Table B-1. ERP Member Comments and GSI Responses on the Water Budget Report (GSI 2020b).

*Santa Clara River Valley East Groundwater Subbasin
Groundwater Sustainability Plan*

**Initial Sustainable Management Criteria for the Alluvial Aquifer at Production Well NWD-Pinetree5
(Based on Measured Historical Conditions)**

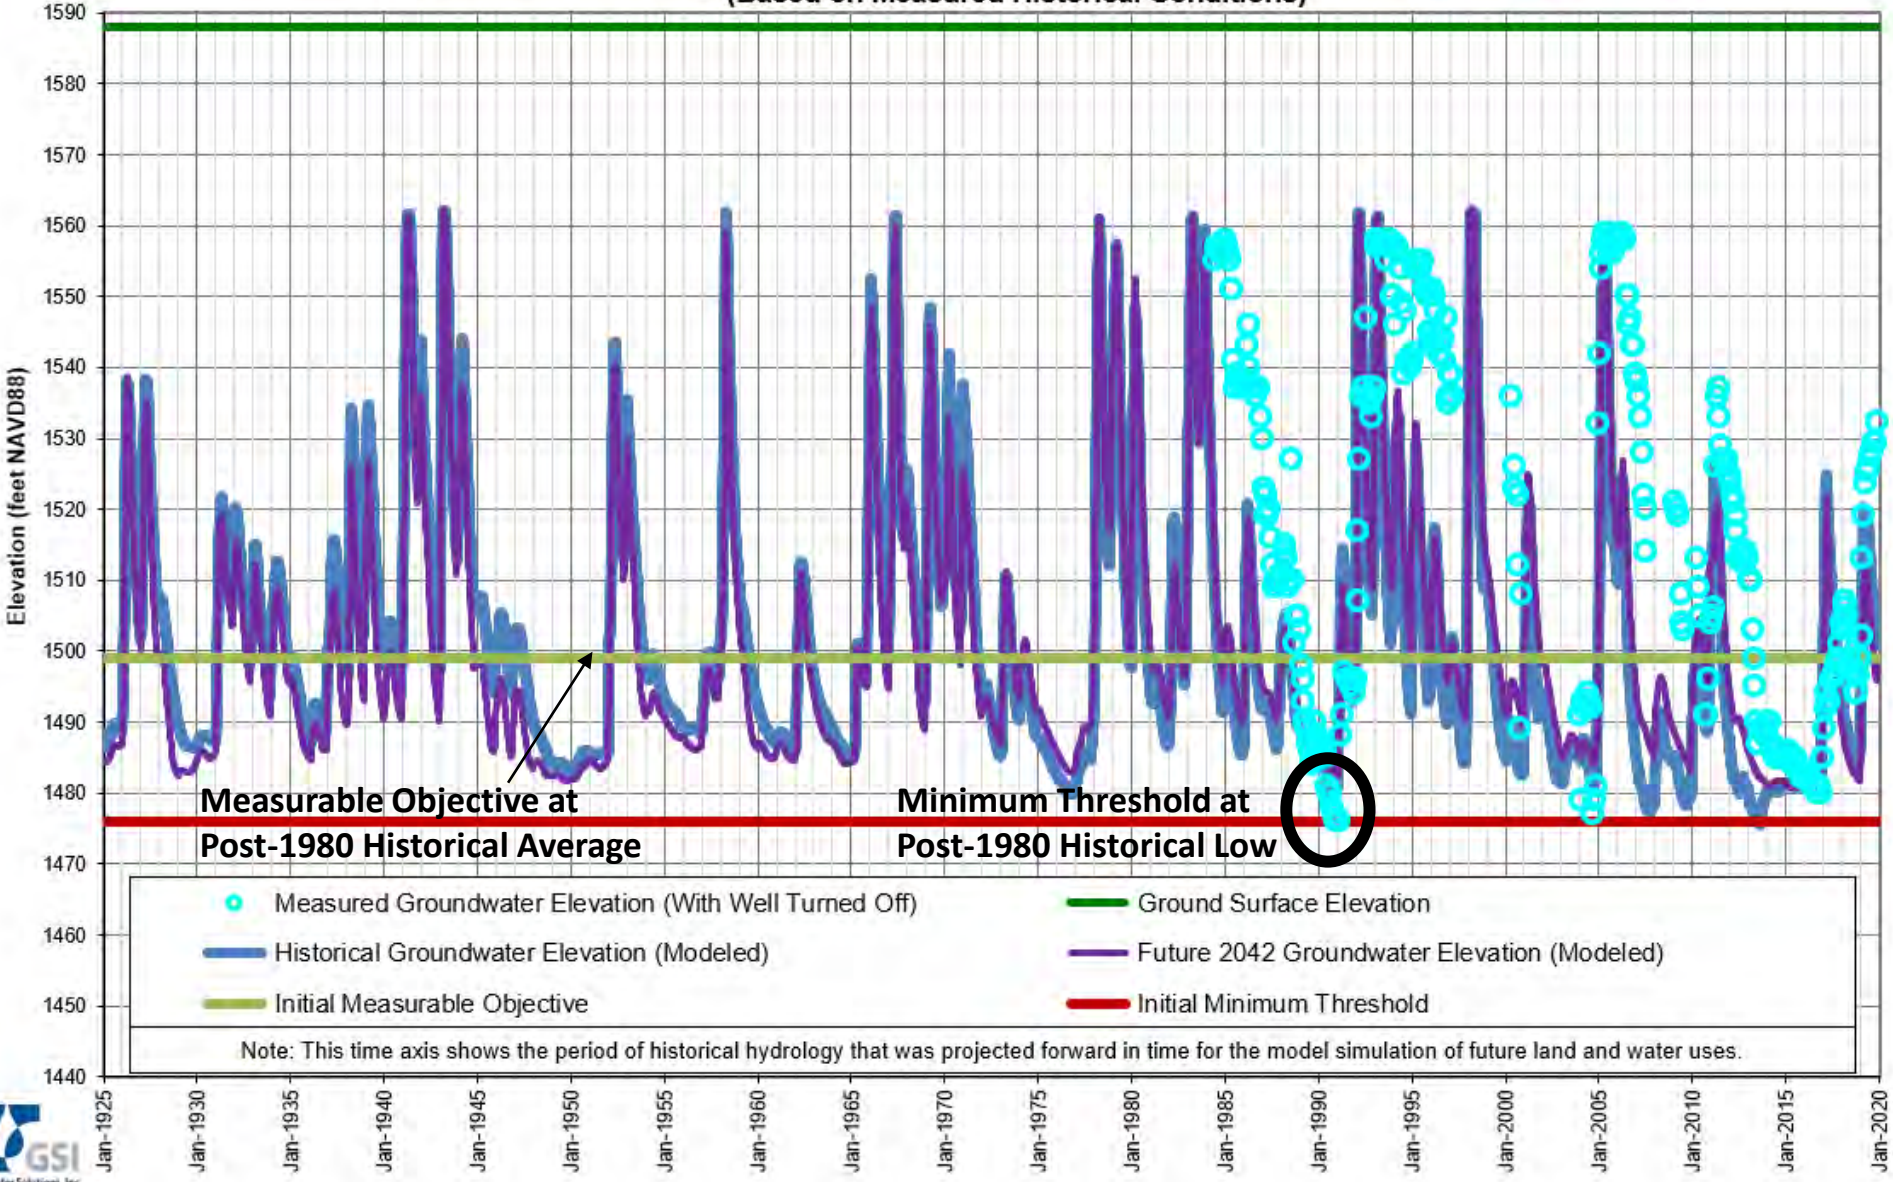
Comment Number	Reviewer	Section	Page	Figure	Table	ERP Comment	GSI Response	Theme
						page 73) and NWD-Pinetree 5 (PDF page 74) do not seem to correspond with either the predicted or measured value, but something in between.		
S-14	N.Brown	8.5.2.3	11	---	---	It is stated "Pumping at, or less than, the sustainable yield will maintain average GW levels in the Subbasin." Not sure what this statement means. Clearly two different pumping conditions cannot both result in maintaining average GW levels. What are you trying to say here?	Revisions have been made to the wording in this section (which is now Section 8.6.2.3).	Needs Clarification
S-15	N.Brown	8.5.2.3	11			2nd to last bullet on page. If you're intending to use GW levels as a proxy for reduction of GW storage, then it would seem that this would be the subsection to begin that discussion. If you're using GW levels as a proxy for reduction of GW storage, then you're essentially saying that avoidance of undesirable results for chronic lowering of GW levels would be also result in avoidance of undesirable results for reduction of GW storage.	We have added a statement about this at the end of that bullet.	Needs Clarification

Initial Sustainable Management Criteria for the Saugus Formation at Production Well VWD-160
 (Based on Projected Full Build-Out Conditions with 2030 Climate Change)

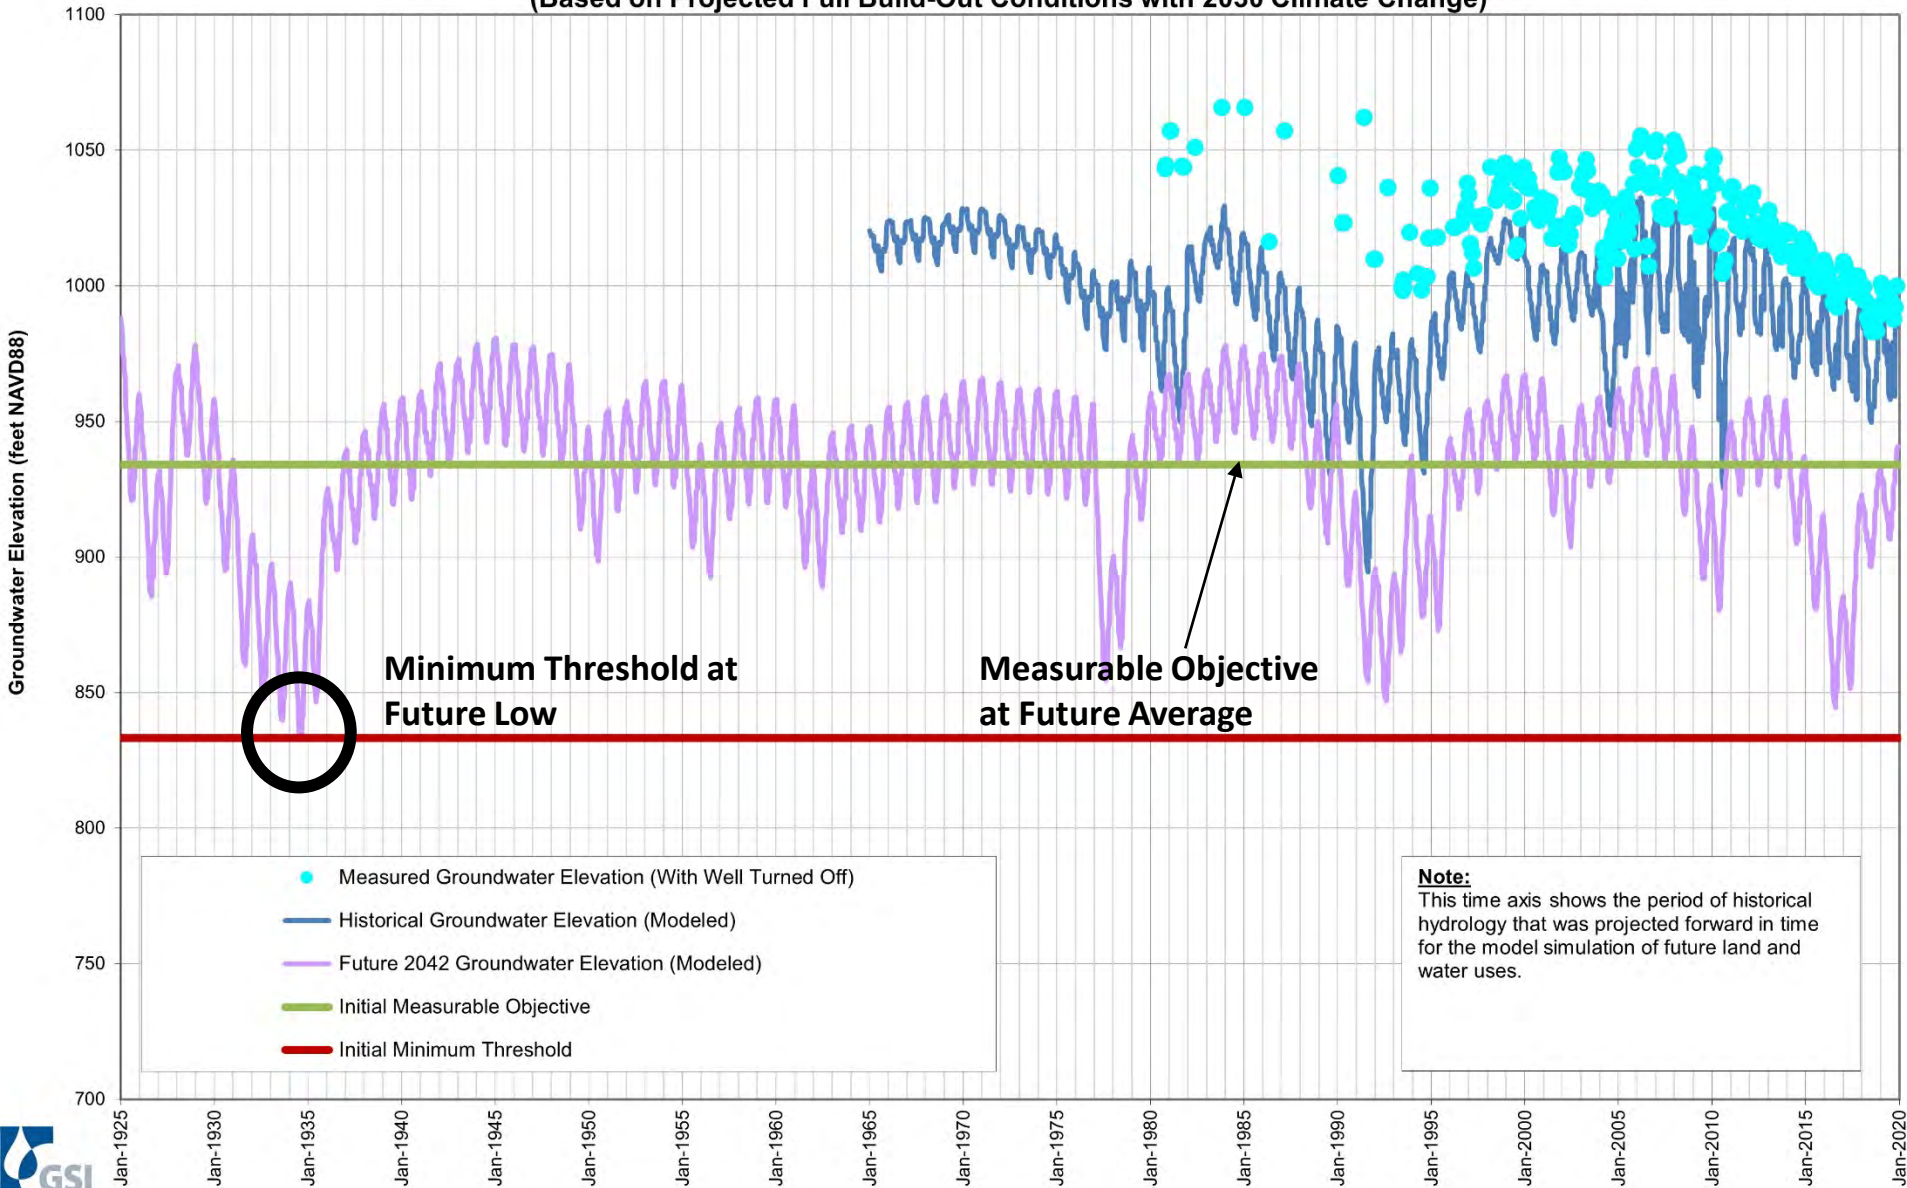
S-31	J.Rumbaugh	Appendix C	---	VWD-160	---	Same as NWD-12	We found that the calculation method described by the reviewer in comment S-30 did not produce reasonable results when tested. We think this is because the max difference between the historic and future model curves does not always coincide with the periods when groundwater levels are lowest in the aquifer. In particular, the max differences may arise from historical seasonal or annual variations in pumping that differ from future seasonal or annual variations in pumping. We also concluded that such a calculation would be difficult to show and explain to a non-	Defensibility

Comment Number	Reviewer	Section	Page	Figure	Table	ERP Comment	GSI Response	Theme
							technical audience. We have elected to simply use the future-conditions model output (GW elevations) since the calibration to historical data looks reasonable at this well.	
S-32	J.Rumbaugh	Appendix C	---	VWD-206	---	Same as NWD-12 - that would put red line about 50 ft higher than shown in the existing figure	See response to comment S-30.	Defensibility
Editorial Comments								
E-1	N.Brown	All	All	---	---	All page headers starting on the Abbreviations and Acronyms page have "Sustainable" misspelled in the header.	This has been corrected.	Miscellaneous
E-2	N.Brown	All	All	---	---	Consider searching and replacing "undesirable effects" with "undesirable results" to be consistent with SGMA terminology.	We have made this revision in a few selected places in the text, but not universally. The original text had intentionally used the term "effects" in certain places to distinguish them from "undesirable results." This was based on the wording that appears in Section 354.26(a) and (b), which use both terms and describe how they relate to one another. Also, in several places we quote portions of the SGMA rules that use the words "effect" or "effects."	Miscellaneous
